ANN ARBOR HISTORIC DISTRICT COMMISSION

Staff Report

ADDRESS: 317 South State Street, Application Number HDC12-195

APPLICATION: The applicant seeks HDC approval to install three fabric blade signs and install horizontal LED light strips.

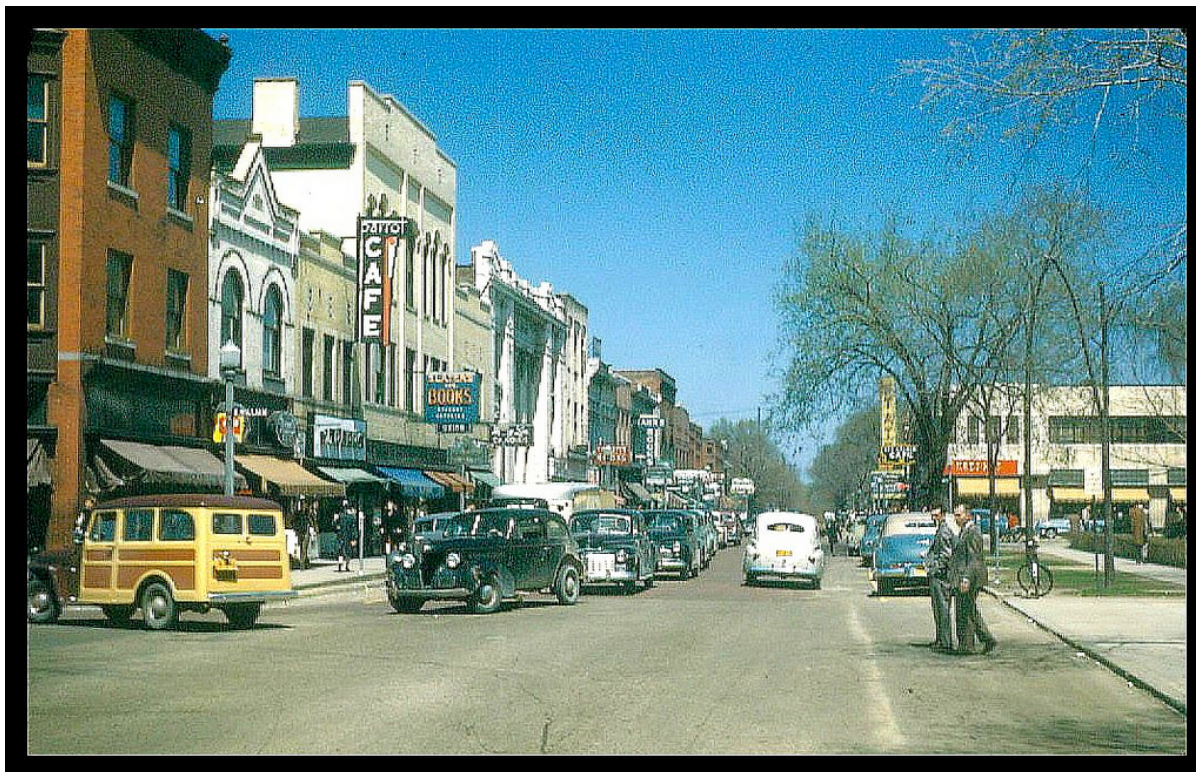
2. The three proposed blade signs are smaller than those considered last month. The signs previously considered were seven feet tall and two feet wide. The newly proposed blade signs measure six feet and one-and-seven-eighths inches high and two feet wide and are illuminated by lamps beneath eat. The signs do not project beyond the upper and lower portions of the character-defining ribbon windows.

3. The blade signs are fabric and lights are shown on the drawing beneath each one. No detail was provided on the uplighting. Two are located on the south elevation along North University Street, and one is located on the west elevation along South State Street. The signs will be gray in color with white text and a white, blue and green logo. The fabric signs will be attached to the building by aluminum arms that are anchored in a ten inch by ten inch aluminum mounting plate.

4. Staff believes that the revised blade signs, with added illumination, are inappropriate and detract from the historic character of the building, the horizontal orientation of the building, the fenestration pattern, and the decorative brickwork on the locations where they are proposed to be mounted. Further, the addition of lights only intensifies the distractive nature of the banner signs. Four canopy signs and two large wall signs have been previously approved for this location; it is staff's opinion that the business will be readily identifiable, and that the addition of blade signs would be a distraction to the character defining features of the building. Staff does not support the first motion below.

5. The applicant seeks approval to install seven horizontal LED light strips above the “Walgreens” wall signs. Three light strips would be located on the south elevation, and four on the west elevation. Based on the submitted information, the lights are proposed to be mounted on the double row of raised bricks surrounding the maroon tiled sign band area. The light bars are 3-¼” square, with 5” diameter round mounting plates on either end. The length of each bar is 36”.

6. The light bars are horizontal and small in diameter, and when mounted in a row will match the length of each sign. Installing the lights in the decorative brick banding around the sign area is not appropriate unless attachments and electrical conduit are run through mortar joints only, and no penetrations are made through the masonry. Also, the color of the light bars should match the tan color of the brick in order to minimize the lights’ appearance from the street. Staff supports the suggested motion below that is conditioned on the color of the light bars matching the building, and that no penetration will be made through any masonry unit.

I move that the Commission issue a certificate of appropriateness for the application at 317 South State Street, a contributing property in the State Street Historic District, to add seven LED light strips on the condition that their color matches the tan brick building, and that no penetrations are made through masonry units in their mounting and electrifications, only through mortar joints. The work as conditioned is compatible in exterior design, arrangement, texture, material and relationship to the rest of the building and the surrounding area and meets *The Secretary of the Interior’s Standards for Rehabilitation and Guidelines for Rehabilitating Historic Buildings*, in particular standards 9 and 10 and the guidelines for storefronts.
